| ITEM: 6.1 | COMMITTEE OF ADJUSTMENT REPORT SUMMARY MINOR VARIANCE APPLICATION FILE NUMBER A016/23 10680 ISLINGTON AVENUE, VAUGHAN |

**COMMITTEE OF ADJUSTMENT REPORT
MINOR VARIANCE APPLICATION
A016/23
10680 ISLINGTON AVE, VAUGHAN**

| PURPOSE OF APPLICATION: | Relief from the Zoning By-law is being requested to permit the construction of a proposed cabana, swimming pool, a retaining wall and proposed reduction to landscaping requirements. |

10680 ISLINGTON AVE
APRIL 14 2023
SCALE 1:200

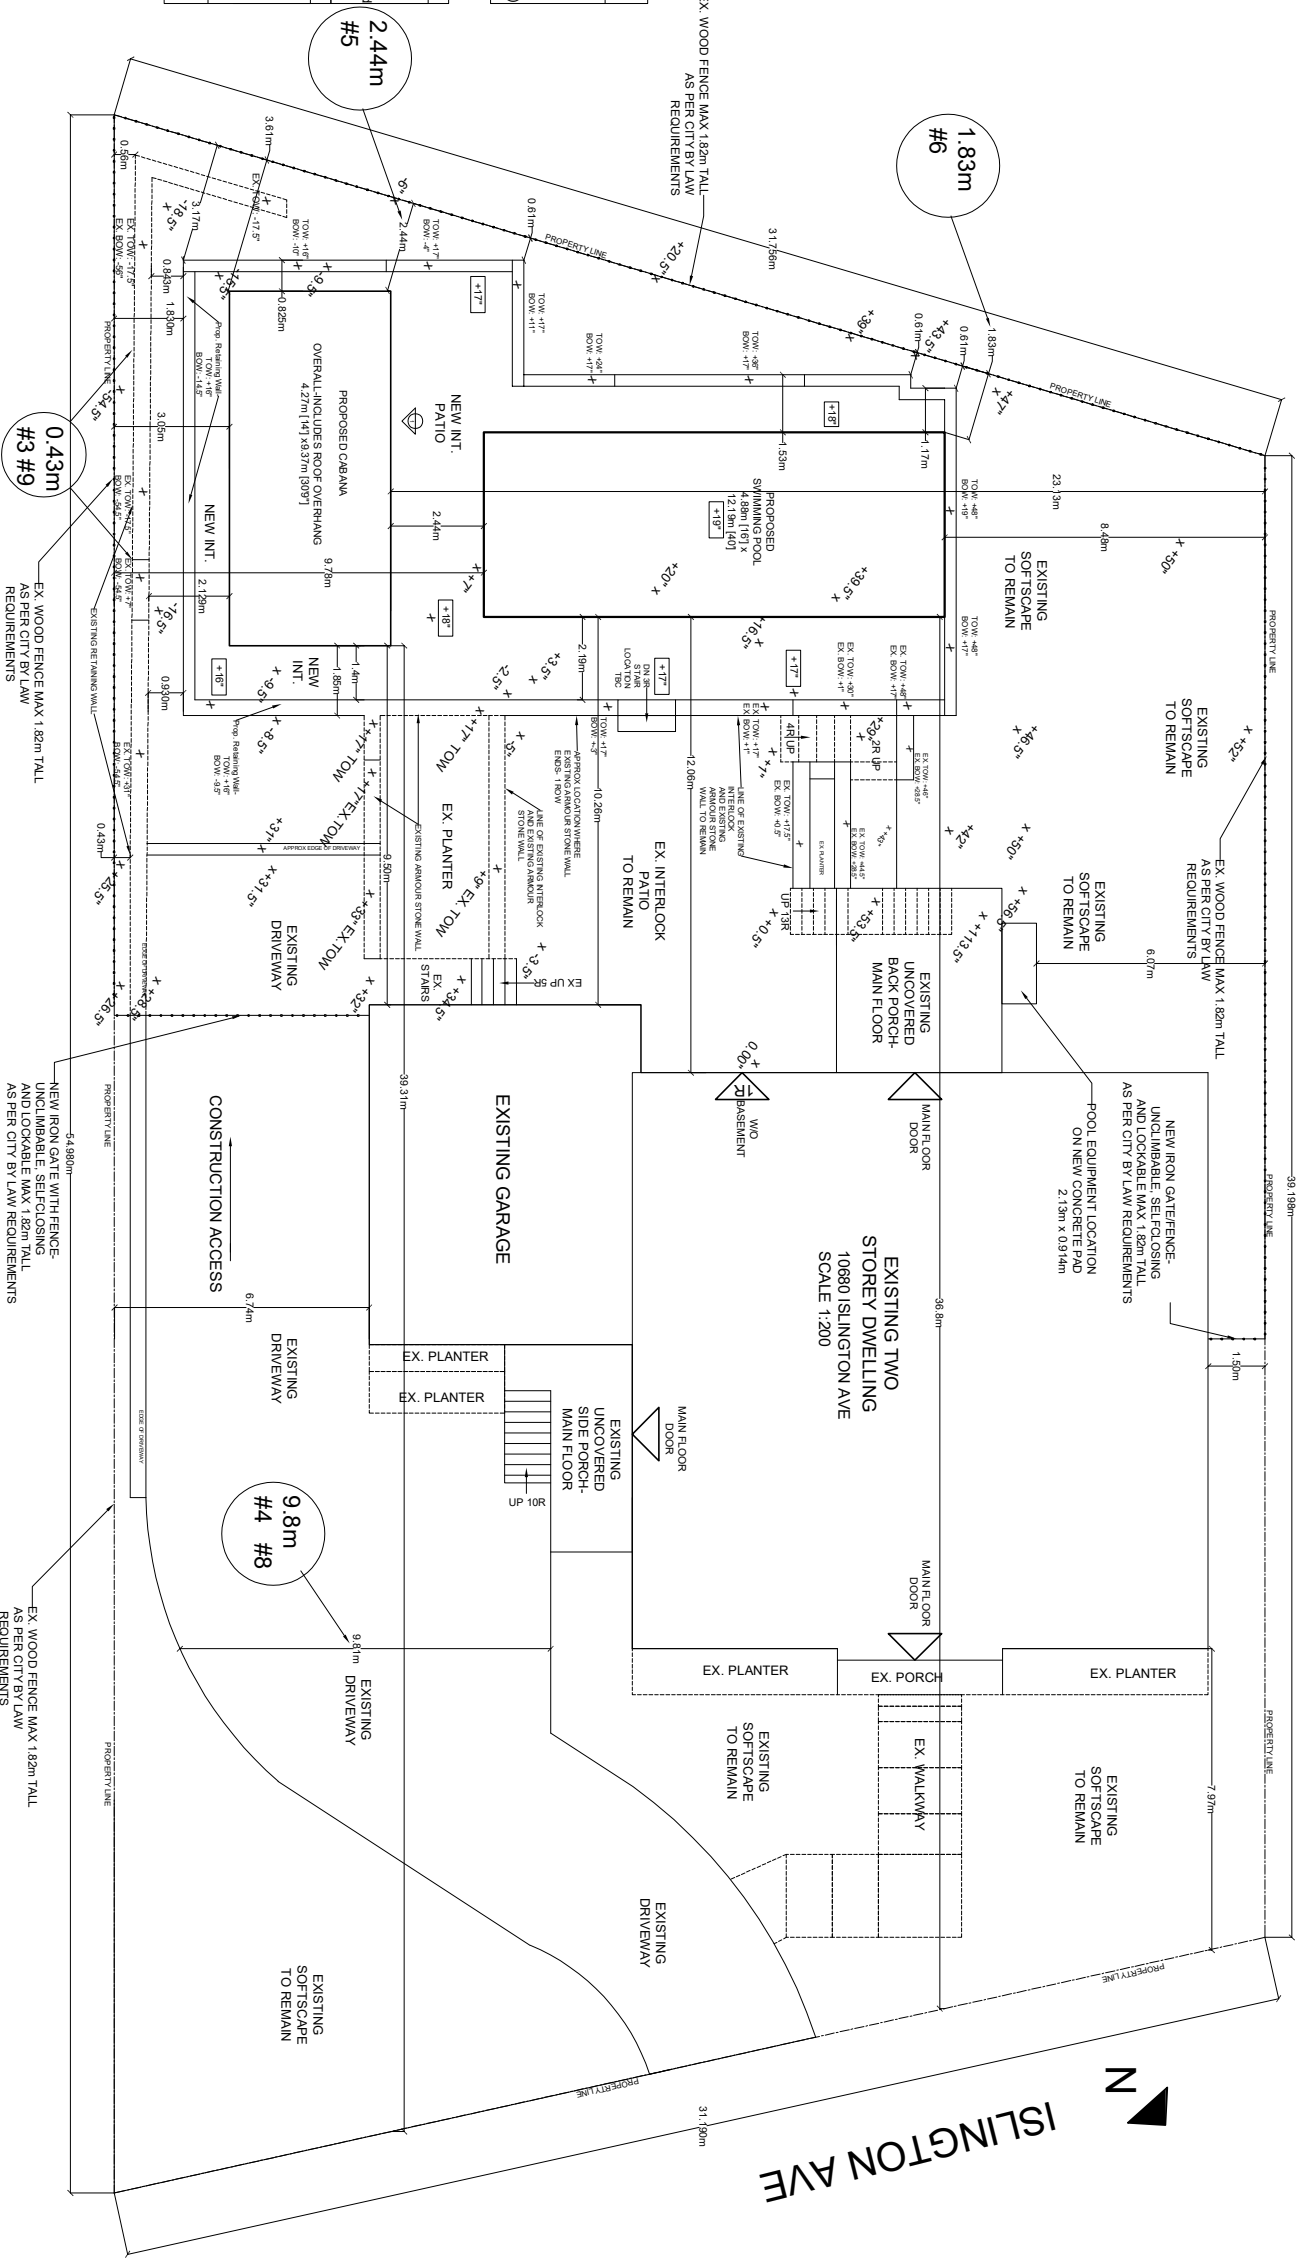
The Development Planning Department has no objection to Variances 1, 6 and 7 for the proposed rear yard hard landscaping. The reduction in soft landscaping is minor in nature and will maintain an appropriate balance of soft landscaping to facilitate drainage and the establishment of vegetation. The Development Engineering Department has reviewed the proposal and is satisfied that drainage in the rear yard will be maintained.

The Development Planning Department has no objection to Variances 2 and 5 for the proposed cabana. The subject property is situated between two roads, fronting onto Islington Avenue and bordering Highway 27 to the rear. There is a significant change in grade throughout the property. The grade lowers the further west the rear yard travels. The 3.82 m height of the cabana is measured from the top of the roof to the average grade. Due to the grade change, the cabana is proposed to sit atop a retaining wall. The height of the cabana when measured from the top of the retaining wall is 3.0 m. The property backs onto Highway 27 and is screened from view by the existing trees in the Right-of-Way. As such, the increased height and reduction to the rear yard setback will not pose adverse massing impacts to the neighbouring properties or streetscape and an appropriate area for maintenance access is maintained. The proposed cabana has also been reviewed by Cultural Heritage staff and will be heard by the Heritage Vaughan Committee on May 24, 2023. Cultural Heritage staff have no concerns with the application; however, the Owners are aware that should the Heritage Vaughan Committee request any changes an additional Minor Variance Application may be required.

The Development Planning Department has no objection to Variances 3 and 9 for the proposed retaining wall as the Development Engineering Department has reviewed the proposal and is satisfied that drainage in the rear yard will be maintained.

The Development Planning Department has no objection to Variances 4 and 8 for the driveway. The driveway curves around and to the side of the dwelling as the access into the garage is located on the dwelling's south side wall. The 9.8 m driveway width is measured at the widest point, but this measurement is taken where the driveway flares out to provide access to a side entrance and only represents a portion of the driveway. When measured at the front lot line the driveway is 4.5 m wide, and when measured in front of the garage the driveway is 5.9 m wide. There are also trees present between the curved part of the driveway and Islington Avenue. As such, the driveway appropriately facilitates the interior side facing garage and will not cause adverse impacts to the existing streetscape.

| Development Engineering Recommended Conditions of Approval: | The Owner/applicant shall submit a revised Lot Grading and/or Servicing Plan to the Development Inspection and Lot Grading division of the City's Development Engineering Department for final lot grading and/or servicing approval prior to any work being undertaken on the property. Please visit or contact the Development Engineering Department through email at DEPermits@vaughan.ca or visit the grading permit link provided above to learn how to apply for lot grading and/or servicing approval. |
